Interactive comment on “Assimilation of space-based passive microwave soil moisture retrievals and the correction for a dynamic open water fraction” by B. T. Gouweleeuw et al.

Anonymous Referee #1

Fig. 1.

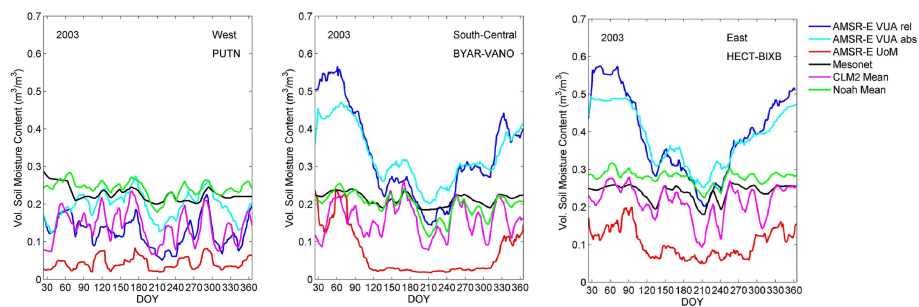
Figures 2: Please specify in the caption the meaning of the grids and the dots.

Reply: The meaning of the dots have been specified in the Figure 2 (now Figure 1) caption:

Figure 1. AMSR-E 0.25 degree gridded absolute soil moisture (m³ m⁻³) retrievals (AMSR-E VUA abs) from the Land Parameter Retrieval Model (Owe et al., 2008) for 2 April 2003 (upper panel) and 28 July 2003 (lower panel). White areas indicate grid cells outside the sensor swath (upper panel, North-West corner) or masked-out grid cells of non-convergence (East and South-East). The AMSR-E grids represented by an Oklahoma (inset, next to key) Mesonet observation stations are outlined.
